INDEPENDENT TECHNICAL REVIEW OF WINTHROP SHORES RESERVATION RESTORATION PROJECT

TECHNICAL REVIEW

The following is Tetra Tech's report on its review of the Winthrop Beach Nourishment Project (also referred to, variously, as the Winthrop Shores Reservation Restoration Project and the Winthrop Shore Protection Design Project; for simplicity, hereafter the "Project"). Responses to questions posed to the Massachusetts Department of Conservation and Recreation (DCR), observations during a site visit conducted by two members of the Tetra Tech Team on 05 May 2016, relevant clarifications provided in a teleconference call held between representatives of DCR, the Parsons Brinckerhoff Team and Tetra Tech on 05 May, and an on-site meeting with DCR staff on 06 May all serve to contribute to the findings of this report.

Figure 2. Plan view of Project Shoreline Contour Plot with Locations of Selected Cross-Sections for Comparison (see Appendix C for representative cross sections comparing the three surveys).

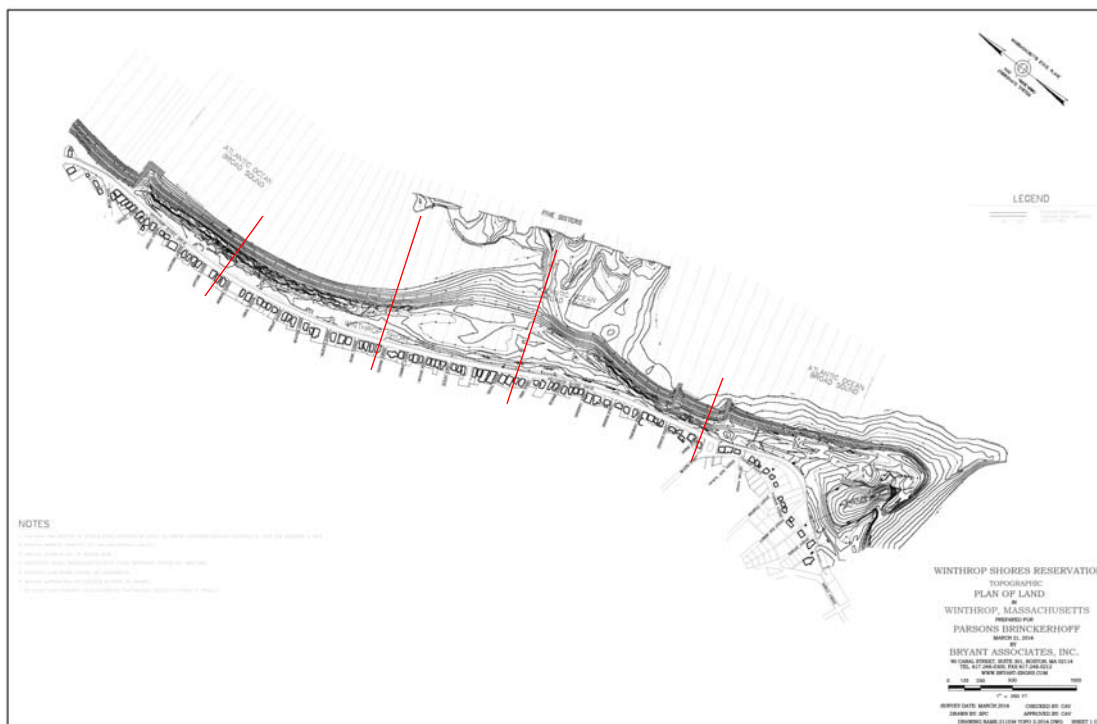
Overall, the survey data shows adjustments that would be expected following a restoration or nourishment project to the upper beach berm position over the time period August 2015 to March 2016, and only modest shoreline position changes at elevation +5. This provides a partial indication of the overall stability of the placed materials.

Photograph 6. Project shoreline in the vicinity of Charles Street.

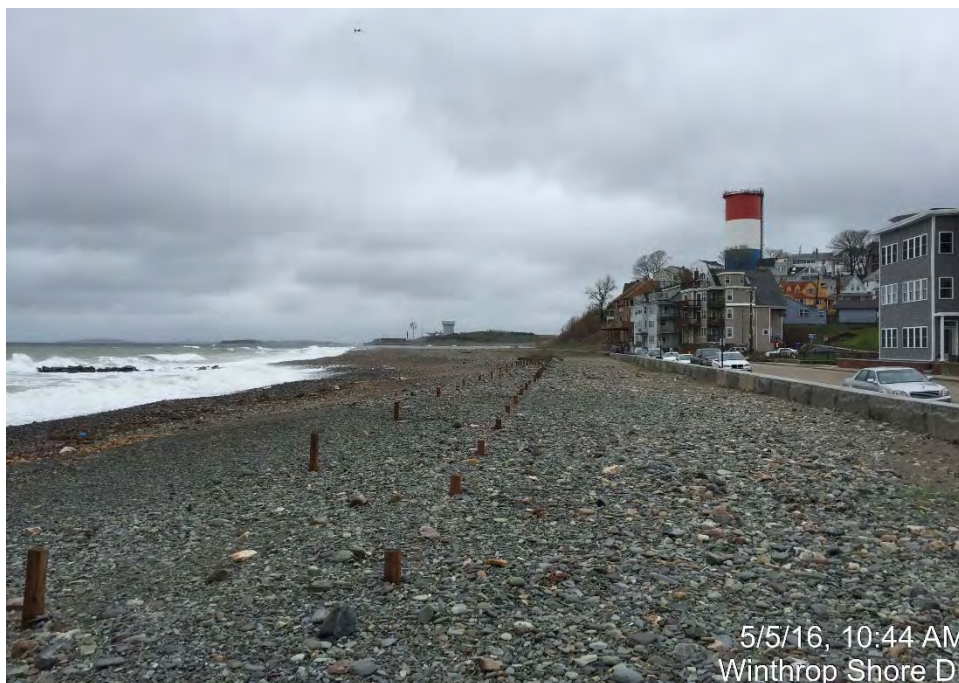
South of Tewksbury Street to the south Project limit, the shoreface was noted to be similarly comprised of gravel and cobble, but the berm slopes were not as steep nor as high in crest elevation as those noted between Seafoam and Myrtle Avenues in particular (Photograph 6).

Photograph 7. Tombolo formation in the lee of the middle Sister and the adjacent breakwater to the south just beyond the time of low tide.

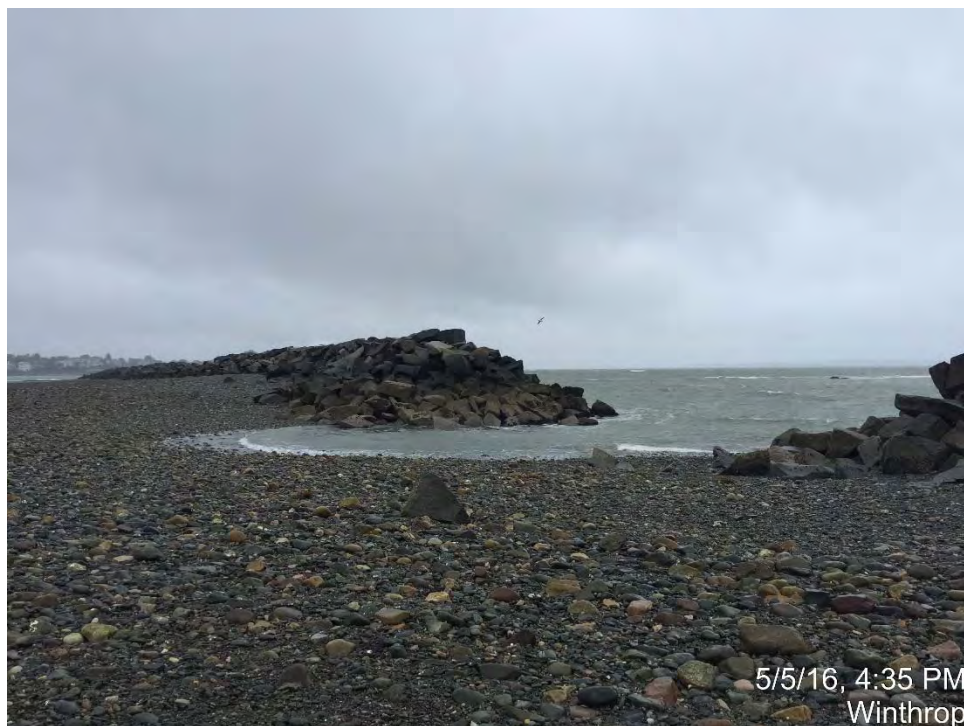
Returning to the beach at low tide (~1545 hours), winds were noted to be generally NE at 20 mph with occasional gusts estimated at 25 mph, moderate to heavy rain, temperature 42 degrees Fahrenheit. With water levels at approximately 1 ft below normal, much of the lower portion of the beach could be readily observed. Again commencing at the south end, Tetra Tech engineers traversed much of the southern shoreline from Groin #5, noting that the seaward terminus of the southernmost two groins were completely emergent. It was possible to walk to the landward edge of the southernmost three breakwaters at this time. A sand and gravel matrix was observed on a low, flat tombolo platform extending to each of these breakwater units. The crescentic gap between the middle and fourth breakwater was estimated to extend landward approximately 50 ft to the water's edge at the time the tombolos were traversed on foot (Photograph 7).

Figure 6. Erosion and deposition of the fill materials.

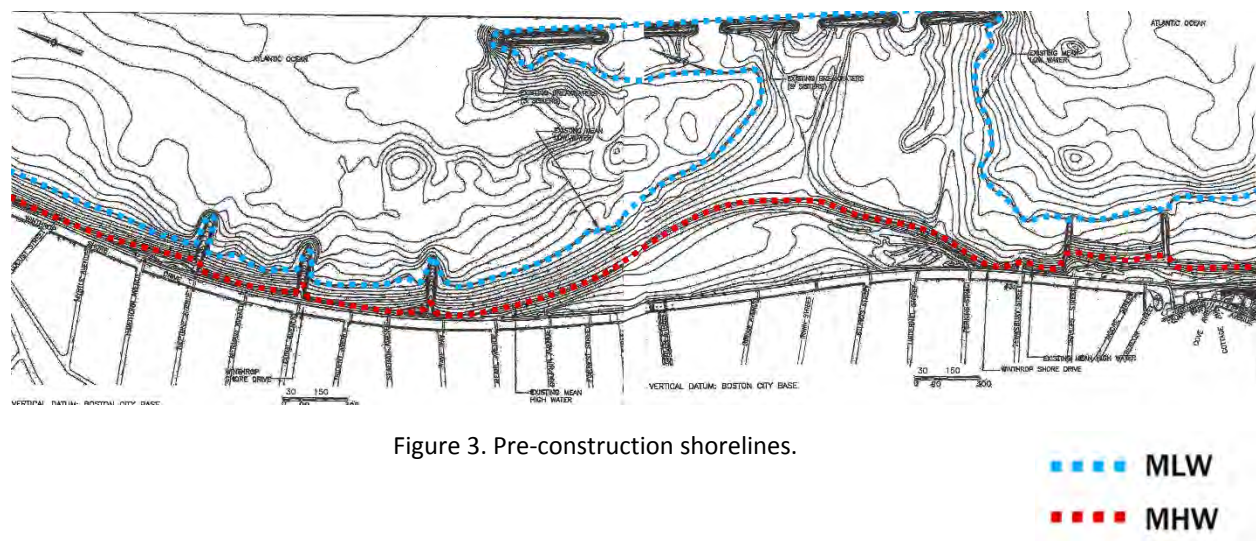
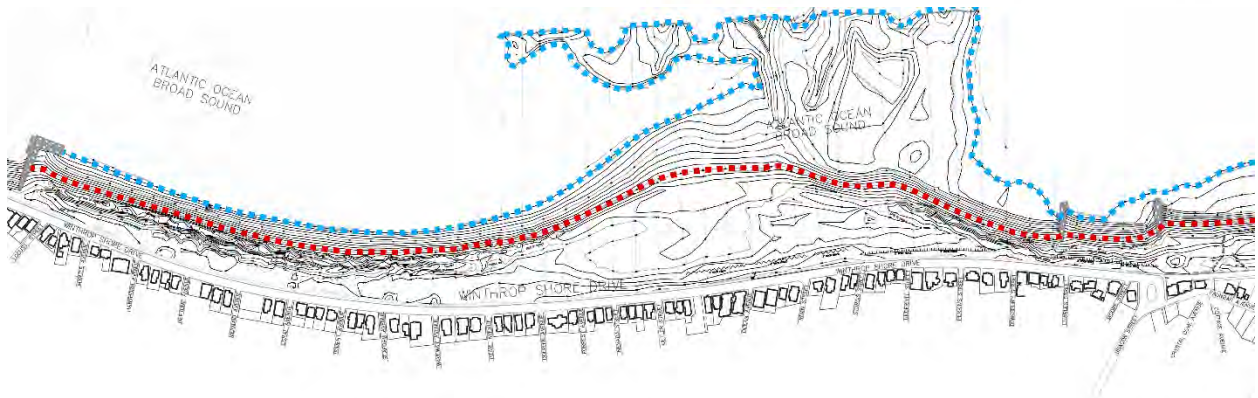
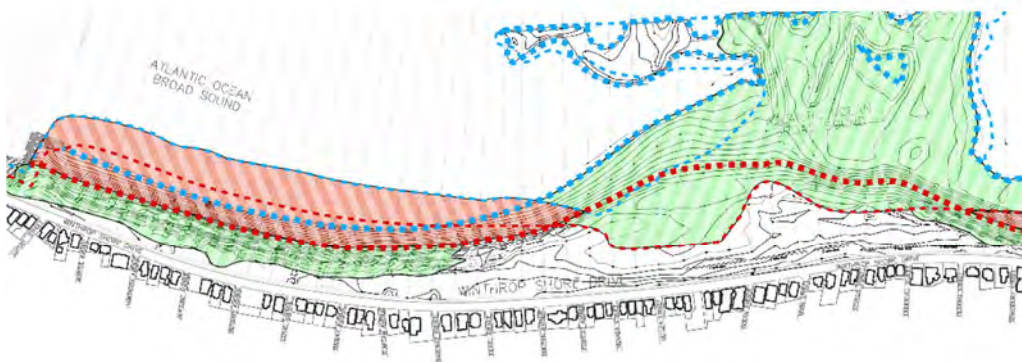
Figures 3, 4 and 5 show the high and low water marks before the Project, as the Project was designed and the Project in March, 2016. These figures are based upon actual field surveys and construction drawings. As is evident from an inspection of the beach today, the wave energy, primarily in the winter and spring of 2015 and 2016, has resorted and redistributed the fill materials which were placed by December, 2014.

In the exposed areas, it may be possible to provide a sandy beach segment adjacent to the seawall that is maintained by a sustainable cobble beach system seaward of the sandy beach. It may also be possible in these exposed areas to flatten the shingle berm profiles by grading the berm crest into the intertidal zone to improve access along all of the beach without destabilizing the protective value of the beach. From a shore protection perspective, a desirable outcome would be to have the shingle berm reside in the intertidal zone during the summer's gentler southwesterly off-shore winds and be available in the winter to be reformed into a tall protective shingle berm for the winter nor'easters. While this activity was not recommended in the earlier Hayes report, it is necessary to provide convenient access to the water and does not threaten the stability of the beach.
